PRODUCT / PROCESS CHANGE NOTIFICATION

1.1 Company	 STMicroelectronics International N.V
1.2 PCN No.	ADG/23/14370
1.3 Title of PCN	STL42P6LLF6 (6B6401): Double Stitch Bonding Introduction
1.4 Product Category	STL42P6LLF6
1.5 Issue date	2023-10-26

STL42P6LLF6 (6B6401): Double Stitch Bonding Introduction

ADG/23/14370

Double Stitches realization

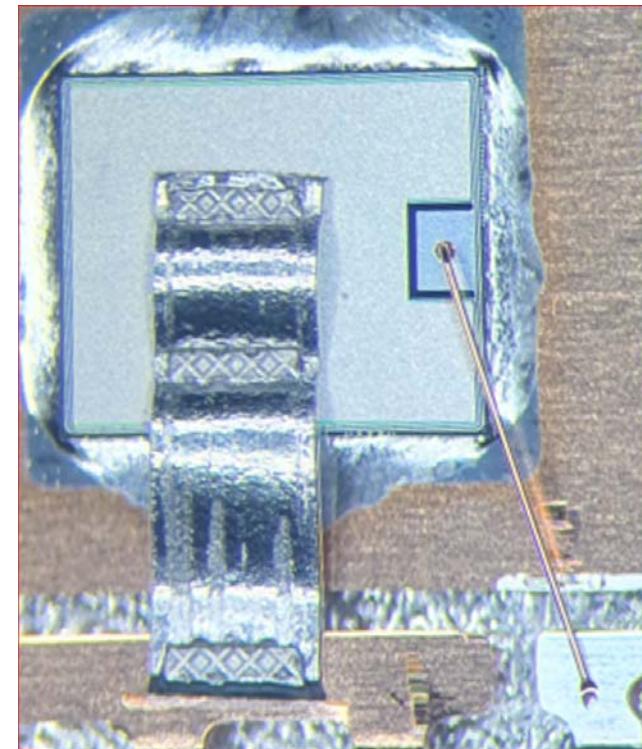
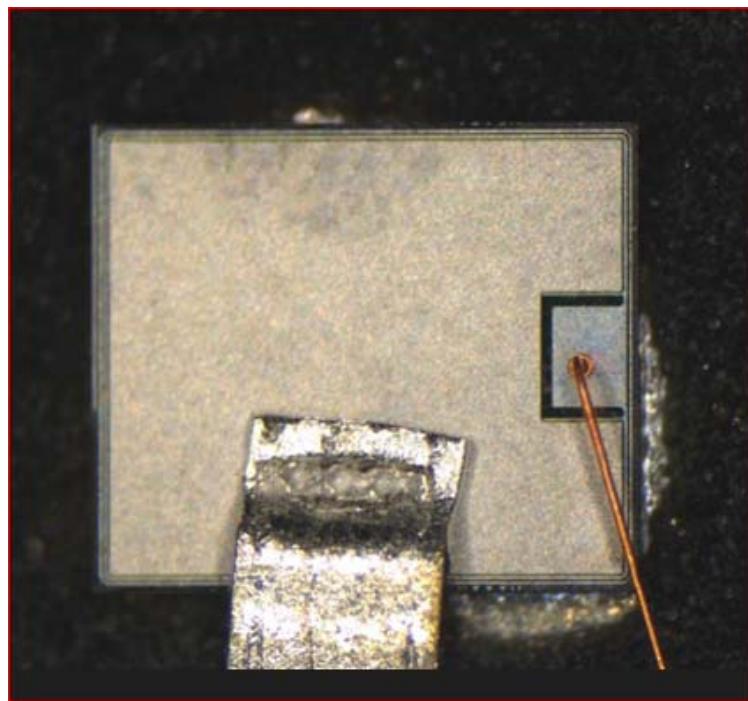
646B Double Stitches CONVERSION from Single Stitch

- Aim of this document is to describe the qualification activity to use ribbon bonding from single to double stitches.
- The TV identified have been :
 - 6B64 (INDUSTRIAL)
- No any change from the rest of Assy step either Testing point of view in TFME and SHZ
- First Reliability lot completed the tests with positive results
- Final Reliability reports will be provided by November
- The new double stitches bonding is ensuring the same quality and electrical characteristics as the current products.
